**BALTIMORE COUNTY, MARYLAND
DEPARTMENT OF PUBLIC WORKS AND TRANSPORTATION
DIVISION OF CONSTRUCTION CONTRACTS ADMINISTRATION
111 WEST CHESAPEAKE AVENUE
TOWSON, MARYLAND 21204**

Contract No. 25010 PO0
Project No's. 107011861
Jacksonville Senior Center Expansion -
3605 Sweet Air Road, Phoenix, Maryland 21131
Phoenix – District 10c3

ADDENDUM NO. 1

DATE: 8/8/2025

SHEET DESIGNATION	CONTRACT NUMBER
T302	25010 P00
	JOB ORDER NUMBER
	PO 10-701-1861
	180 OF 195
	DRAWING NUMBER
2025-0397	
FILE NO.: 8

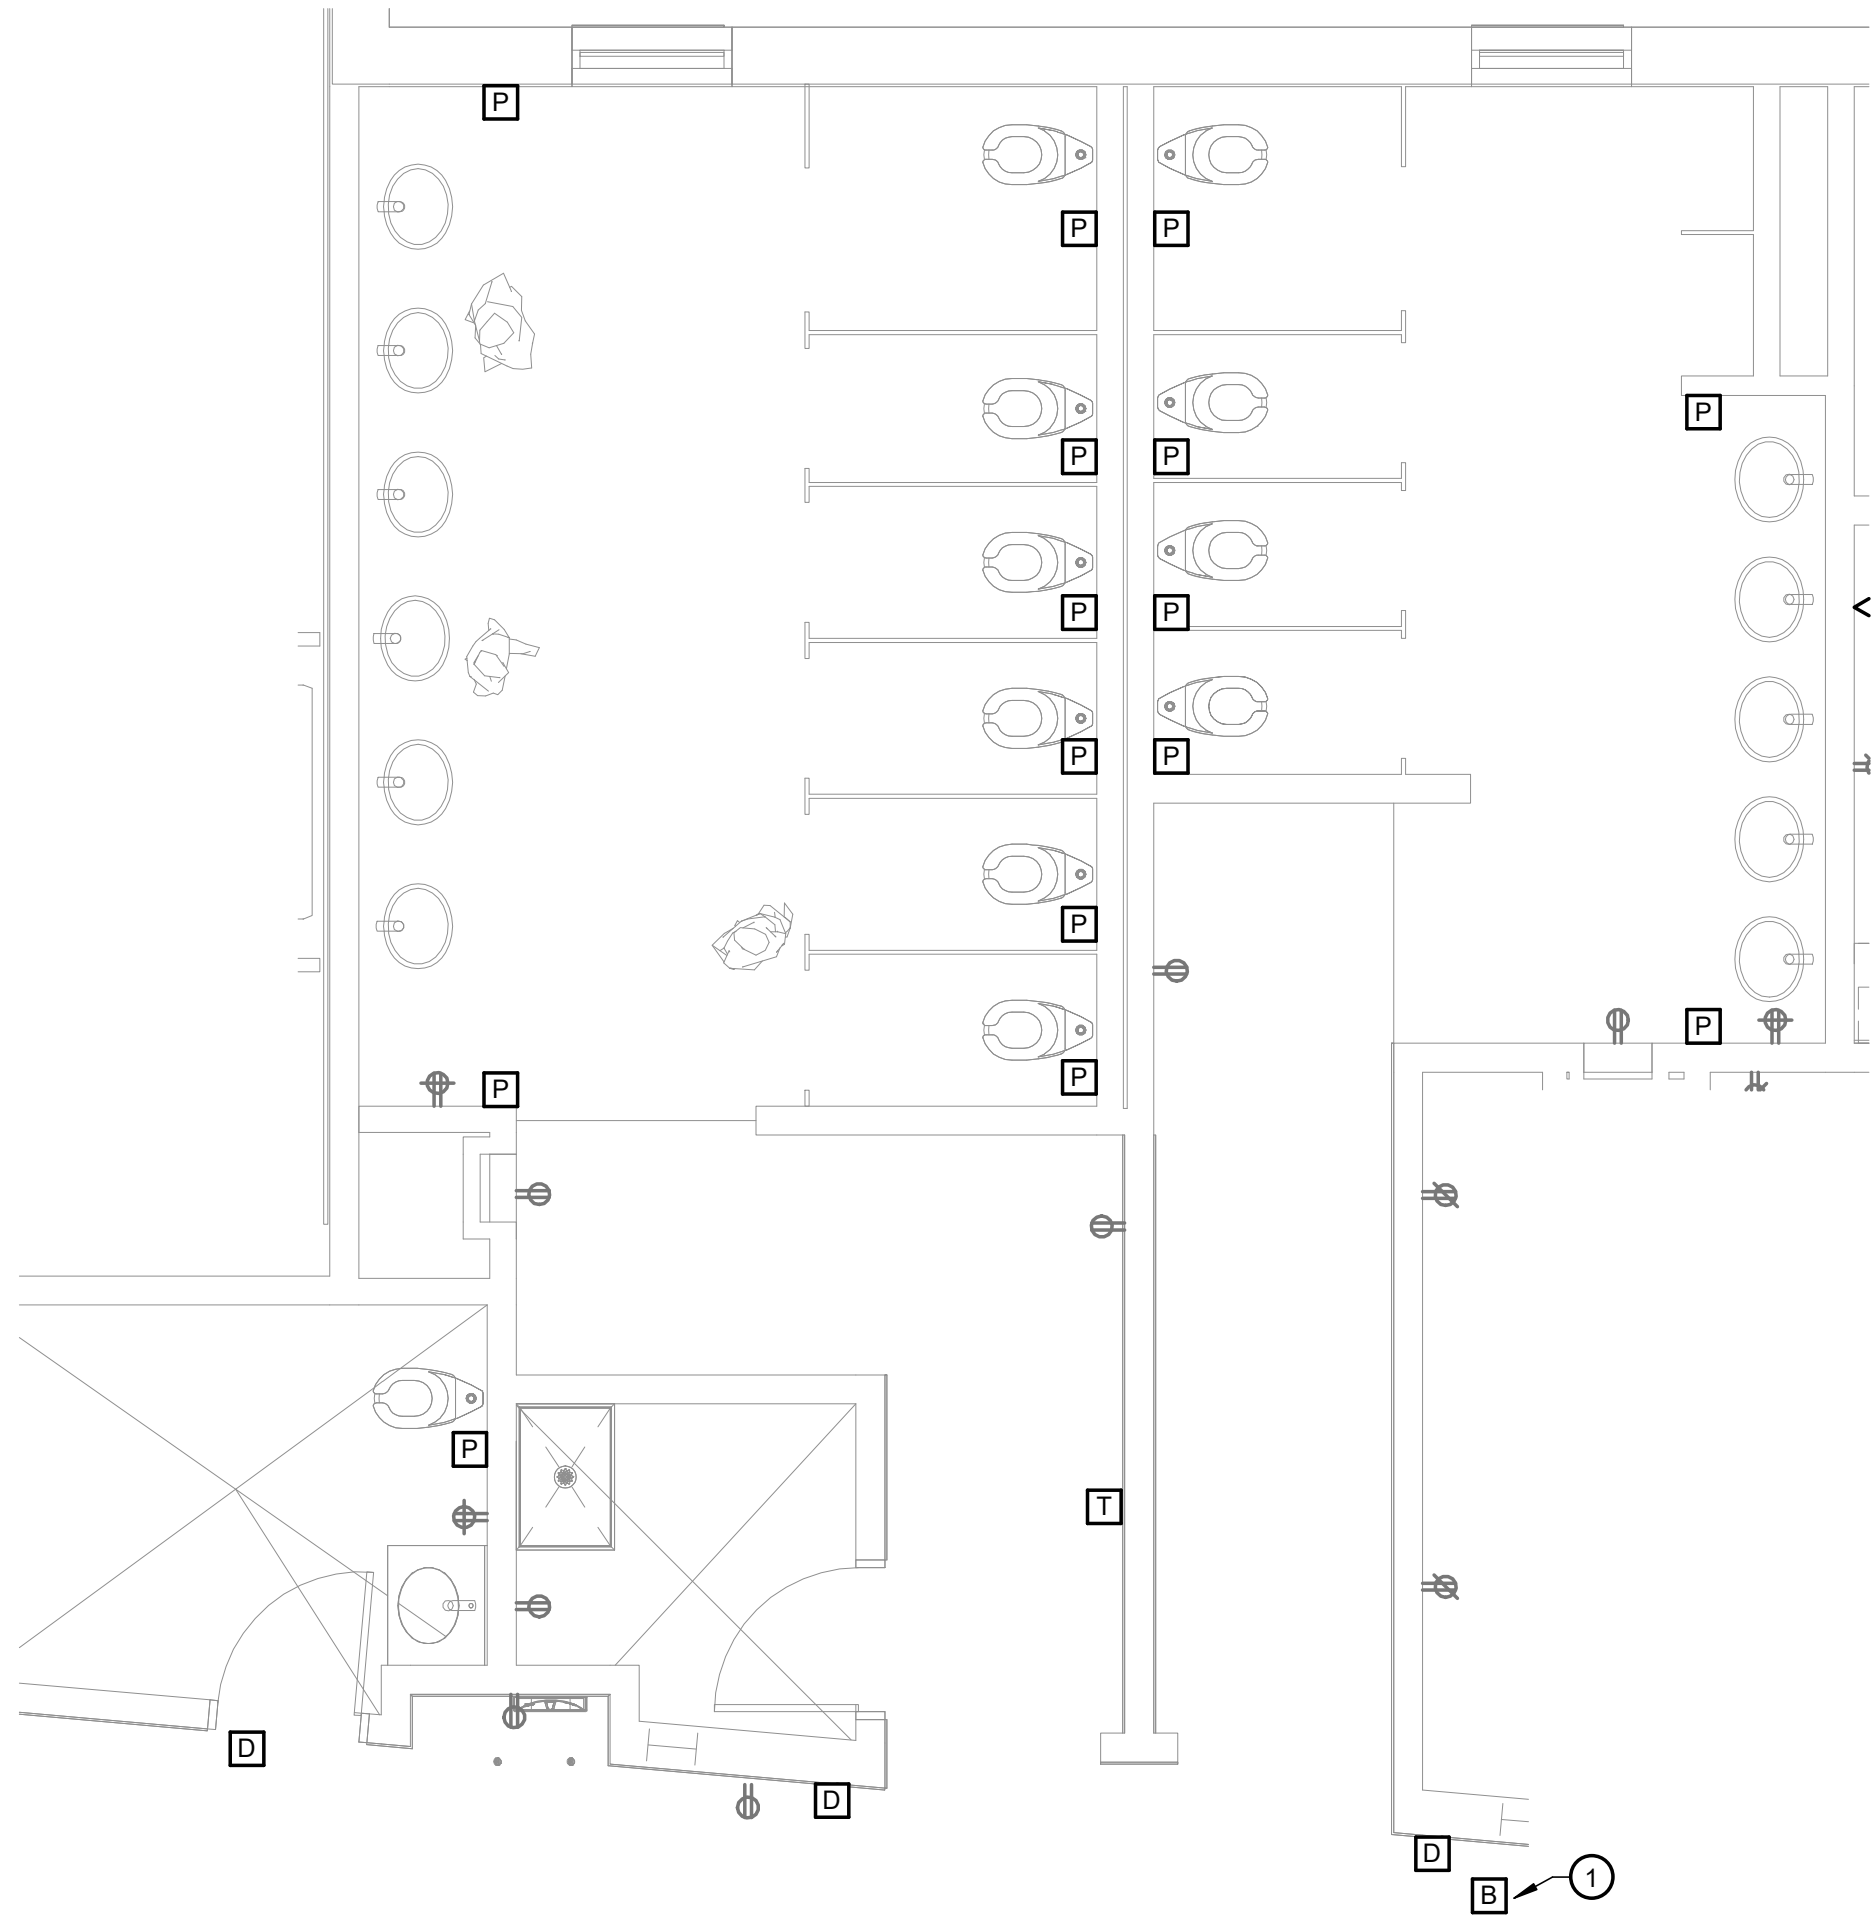
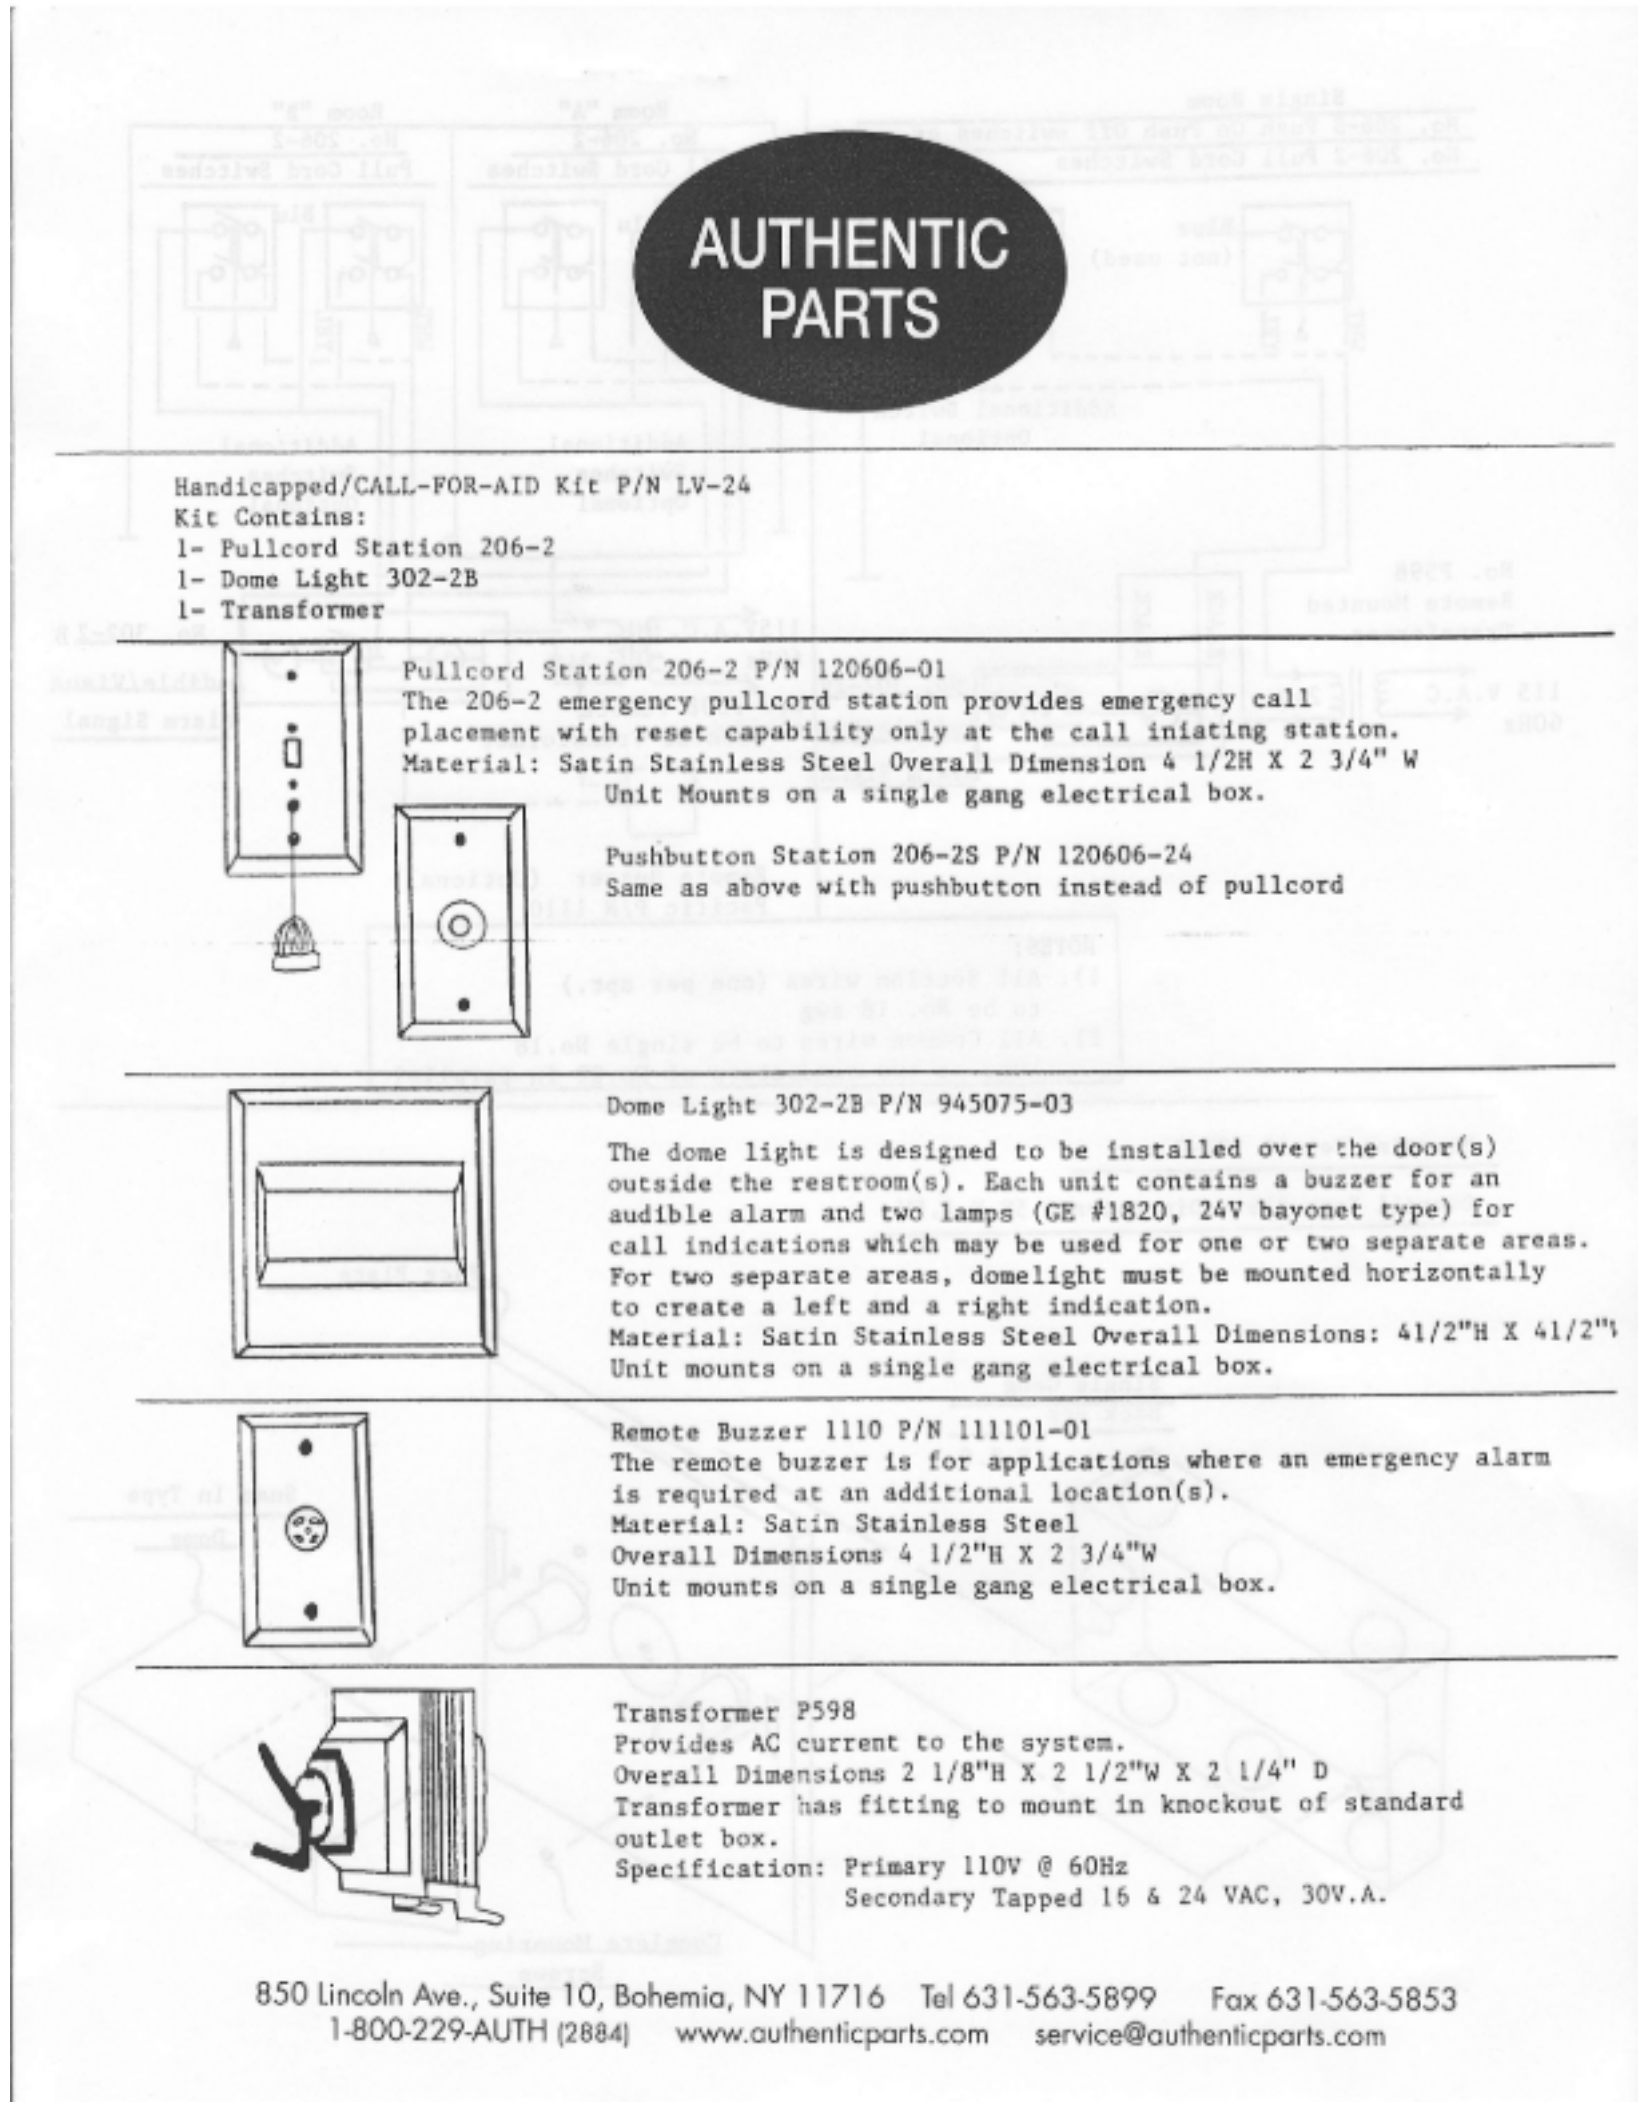
80	On A701 it indicates mini blinds at the windows. On A309, note 3 states to provide electric translucent roller shades. Please confirm the window treatment type needed.	See spec section 12 24 13 Window Shade Systems for products
81	On sheet A310, detail1 the storefront systems show SF-28. Please confirm where SF-28 is located.	Confirmed, there is no SF 28 in this project.
82	Please provide fire pump control specifications for electric-drive, vertical turbine fire pump equipment in Section 213213.	See revised specs section 21 32 13 to include fire pump controller information.
83	Please advise if electronic/digital signatures are an acceptable means of authentication and intent to be bound by/obligated to a submitted proposal.	See Page 3 of the Contract Proposal book for instructions on completing the bid process
84	Drawing T001 indicates that the contractor is responsible to furnish and install the Call-For-Aid system. Please provide a specification for this system.	See Sheet T001 and Revised sheet T302 for information
